Docket Item # 8
BAR CASE # 2008-0154

BAR Meeting
October 1, 2008

ISSUE: Addition
APPLICANT: Ray Lewis
LOCATION: 615 South Fairfax Street
ZONE: RM/Residential

Figure 4: Proposed Elevations

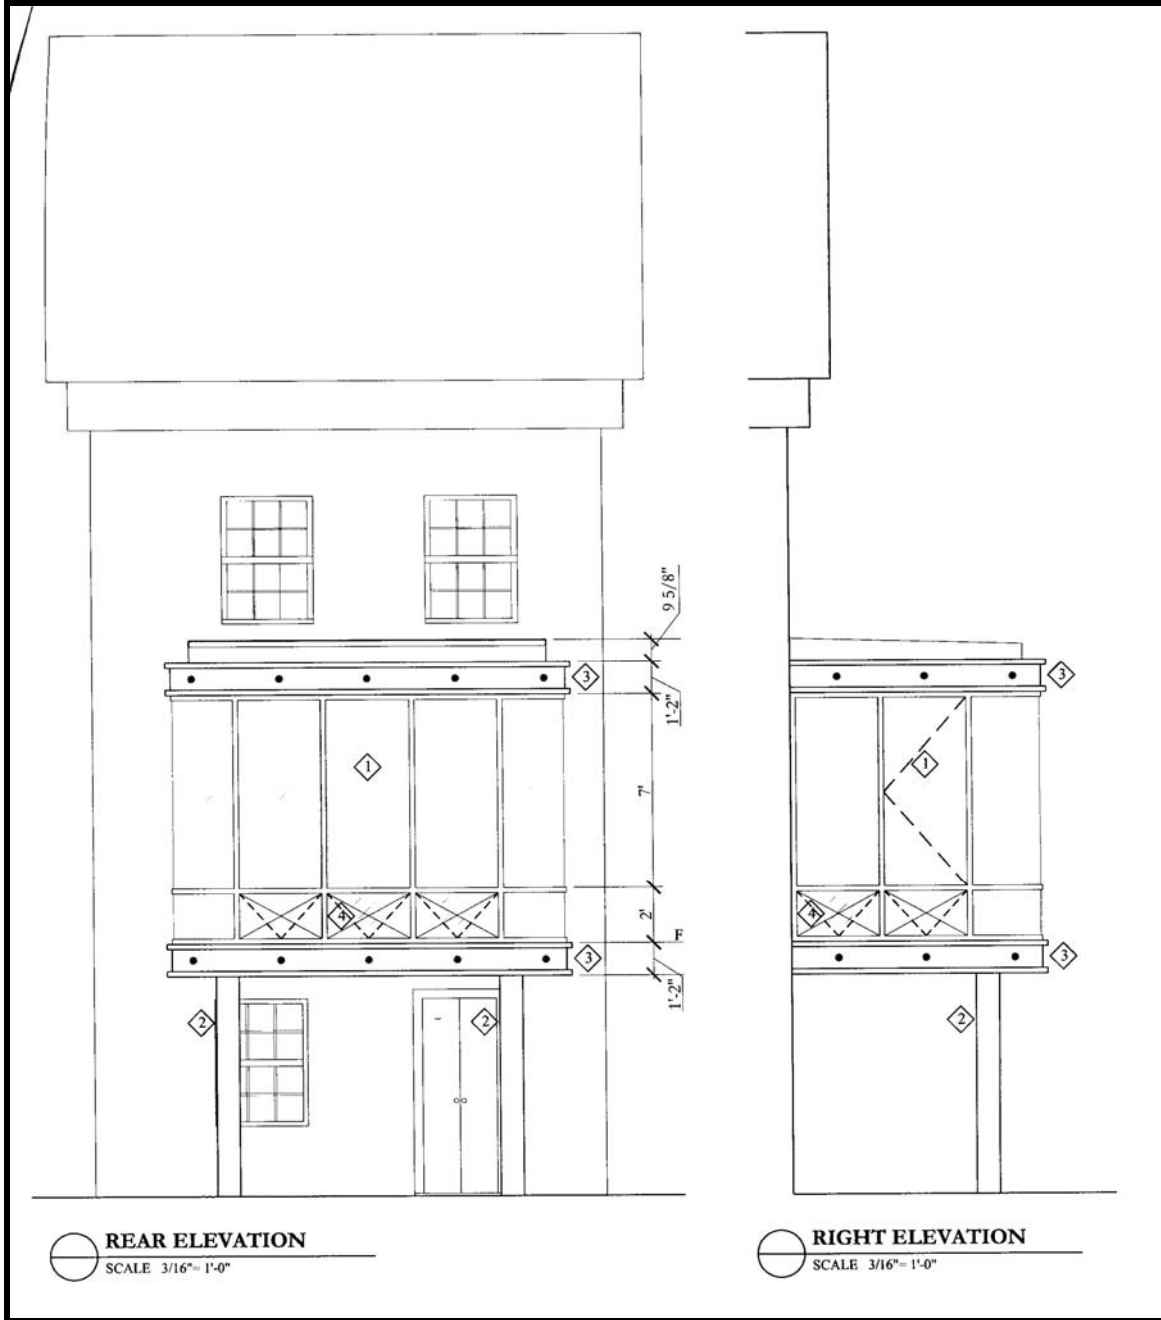
Staff notes that the Office of Historic Alexandria recommends replacing the proposed concrete columns with brick piers. Staff agrees that the concrete columns seem rather simple and utilitarian in design. In the opinion of Staff, it would be more appropriate to use steel I-beams to form the support columns as this the same material used to frame the upper portion of the addition.

S-1 Replace round concrete columns with square brick columns.

1. That the support columns be constructed of steel beams;
2. That the statements in the archaeology conditions below shall appear in the General Notes of all site plans and on all site plan sheets that involve demolition or ground disturbance (including Basement/Foundation Plans, Demolition, Erosion and Sediment Control, Grading, Landscaping, Utilities, and Sheeting and Shoring) so that on-site contractors are aware of the requirements:
 - a. The applicant/developer shall call Alexandria Archaeology immediately (703-838-4399) if any buried structural remains (wall foundations, wells,
